4 December 2017

39 BOYLE STREET - BALGOWLAH, NSW S/96 NEW SWIMMING POOL & INFRASTRUCTURE – DA13/2016 NEIGHBOURING FIG TREE - ARBORICULTURAL ASSESSMENT REPORT

Ref No RTC-17117

Figure 1, showing swimming pool location

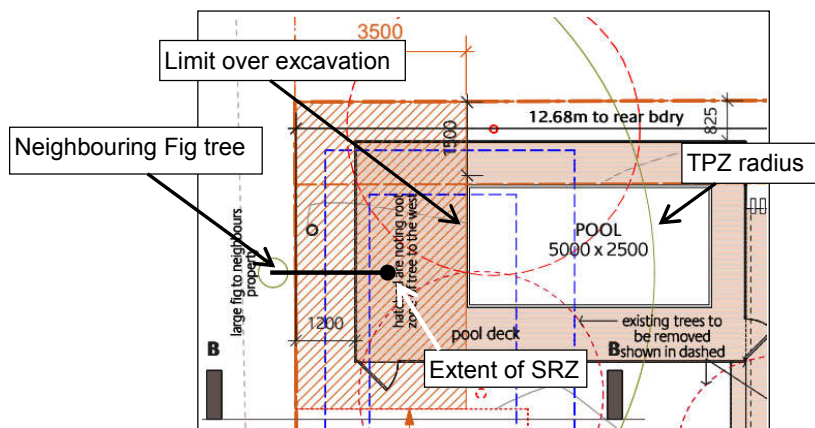
- 1.3 Based on the documentation reviewed the swimming pool footprint has been located outside of the 2.7m SRZ with the overall decking envelope (above ground level encroachment) considered minor and/or manageable at <15% of the 7.8m TPZ.

- 1.4 Provided no significant root severing occurs within the SRZ to accommodate decking foundations the overall TPZ loss and/or coverage by the proposal is unlikely to have an adverse impact on the tree.

- 1.5 To ensure the tree remains viable the following recommendations are provided:
- The extent of over excavation to accommodate the swimming pool is to be limited to 0.2m (200mm) beyond the proposed pool line as shown within construction drawings. The excavation is to be supervised by an appointed project arborist to treat any encountered tree root/s

- Where pier footings for deck construction is required within the 2.7m SRZ a pier footing plan is recommended to be provided for arborist review. Hand excavation is to be conducted under the supervision of an appointed minimum AQF Level 4 certified arborist ensuring tree roots at or >30mm(Ø) remain intact, are not damaged or frayed by works
